REFERRAL REPORT

TO: Vancouver City Council
FROM: General Manager of Planning, Urban Design and Sustainability
SUBJECT: CD-1 Rezoning: 2209-2249 East Broadway

Figure 4: Proposed Site Plan

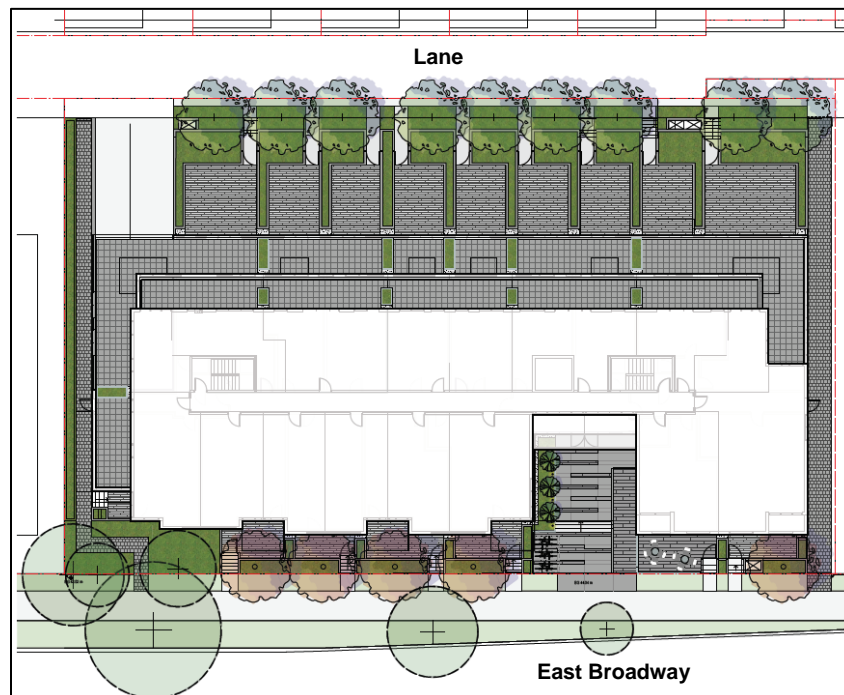
Form of Development — The rezoning site, with a total frontage of 60 m (198 ft.), qualifies for the conditional six storeys permitted in the Plan. The proposed building has a total south side frontage of 56 m (184 ft.), which is divided into two primary frontages by an inset 8 m (27 ft.) wide entrance courtyard. At grade, the building is set back the required 5.5 m (18 ft.) from back-of-curb at the south side, with an additional 3.0 m (10 ft.) provided between the front property line and the building face, except where the narrowing of the boulevard along Broadway occurs starting at the approximate midpoint of the site and continuing east, resulting in the mass of the building extending into the setback a distance of 0.5 m (1.7 ft.) up to 1.3 m (4.3 ft.). Staff have determined that this extrusion into the required setback is not supportable and have provided a related condition.

Further, staff have determined that the high traffic volume of East Broadway necessitates consideration for additional setting back of the ground-level dwelling units on the south side of the building, and have prepared a recommendation to provide for additional separation, provided such measures do not result in additional shadow impacts of the properties to the north. A rear setback of 10.7 m (35 ft.) is provided and there is a further setback in the building footprint at the southwest corner of the development to secure the retention of existing mature trees.

1. Design development to provide for a minimum 3 m (10 ft.) front yard setback in addition to the 5.5.m (18 ft.) SRW from back of curb across the entire width of the south frontage.

Landscape Concept Plan (Ground Floor)

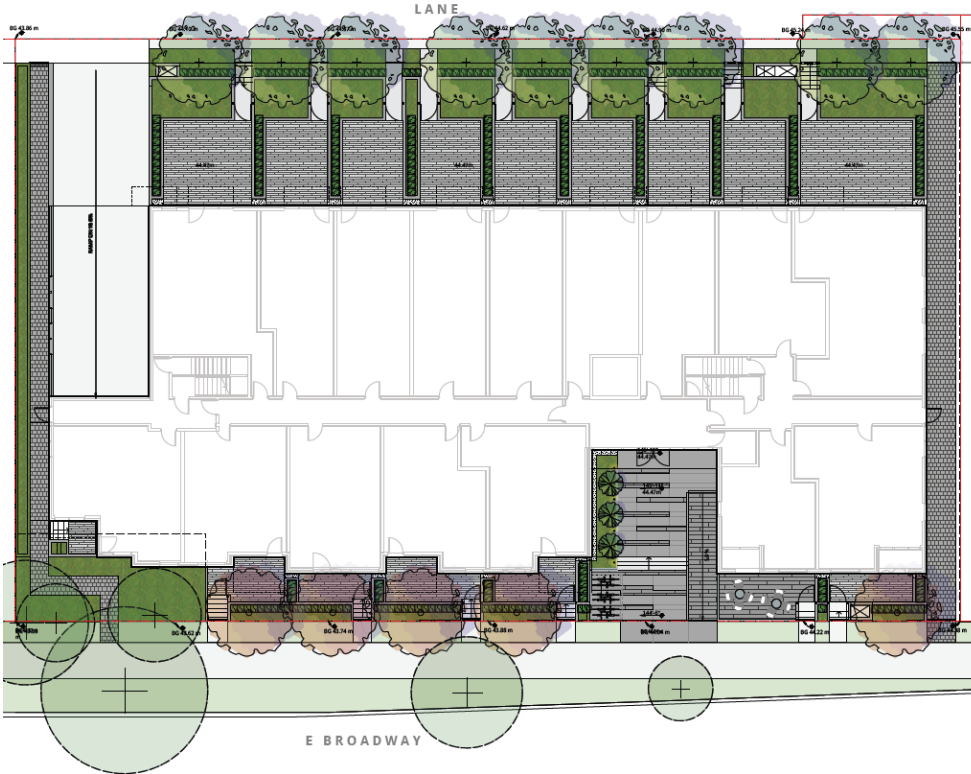
8. Design development to the entry courtyard to achieve a friendly, identifiable and usable space, as follows:
 - (a) Align and improve connection with the common outdoor amenity space;
 - (b) Expand programming and articulation by including a variety of active and passive uses, which encourage common gathering;
 - (c) Relocate ramp to allow for a more holistic, integrated space; and
 - (d) Provide planting that is flush with grade, rather than raised planters, by lowering the parkade below.

11. Design development to the landscape treatment to increase the volume of soil, tree canopy cover and planting on slab, by lowering the slab for planting on the main level to the greatest extent possible, rather than planting in raised planters.
